Revised Structure Type Study

SR-823 Mainline over Fairground Road

SCI-823-0.00
PID No. 19415

• ODOT Review Comments of Original Structure Type Study with Consultant Responses

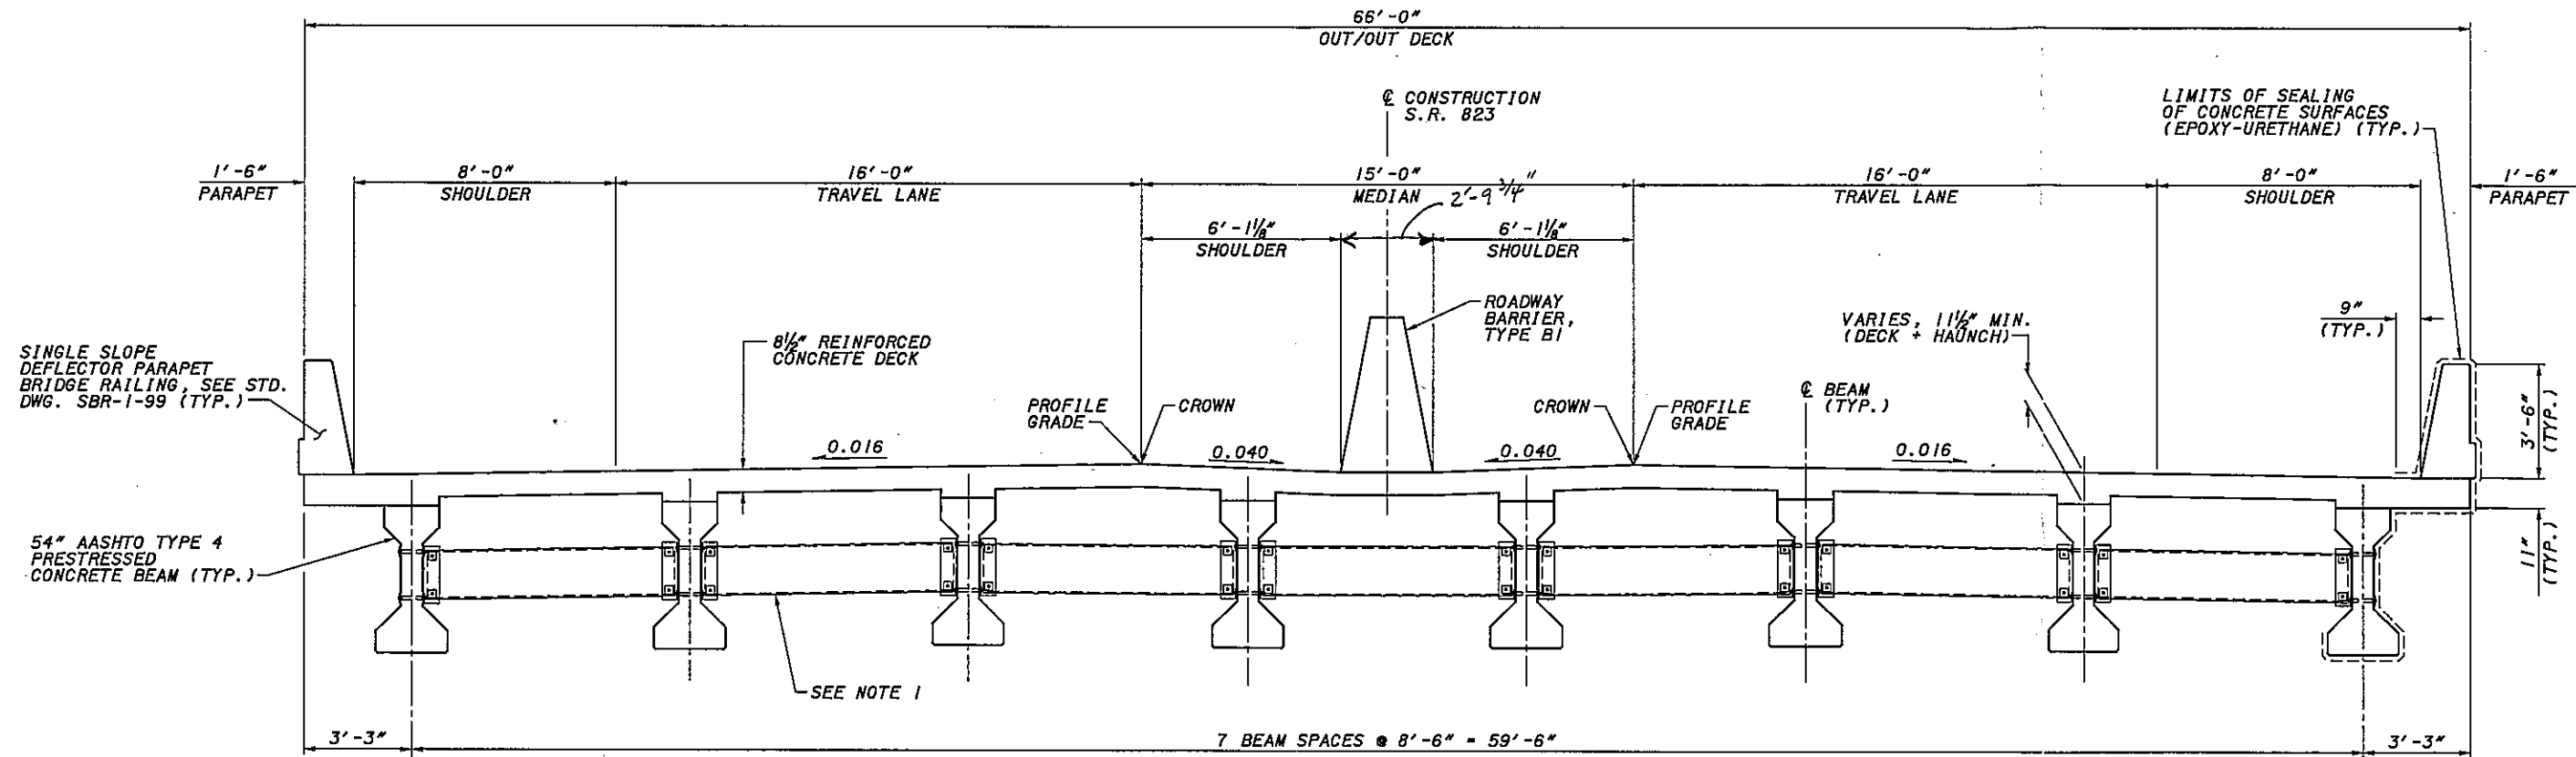
8. What is the required clearzone for this roadway type and speed limit (Fairground Road).
9. Is there any savings from lowering the profile grade so that the actual vertical clearance closely matches the required vertical clearance. If so this should be done prior to finalizing the plans.

<p>Site Plan (1/3)</p>	<p>9. Is there any savings from lowering the profile grade so that the actual vertical clearance closely matches the required vertical clearance? If so this should be done prior to finalizing the plans.</p>	<p>Per the L&D Manual, the preferred vertical clearance for Fairgrounds Road is 15'-0". In this re-submittal package, we are proposing a structure with minimum vertical clearance of 21'-5". The profile grade is being driven by the SR-823 Mainline over Norfolk Southern/US 23 bridge to the west, specifically with the addition of two new Norfolk Southern rail lines per District direction in March 2006. The re-submittal of the SR-823 Mainline over Norfolk Southern/US 23 bridge will be provided at a later date.</p>
<p>Site Plan (1/3)</p>	<p>10. On the final Site Plan:</p> <ul style="list-style-type: none"> a. In the Proposed Structure data block described the roadway width as toe to toe of barrier. b. Provide the PID in the title Block with the Project Number. 	<ul style="list-style-type: none"> a. Will Comply. b. Will Comply.
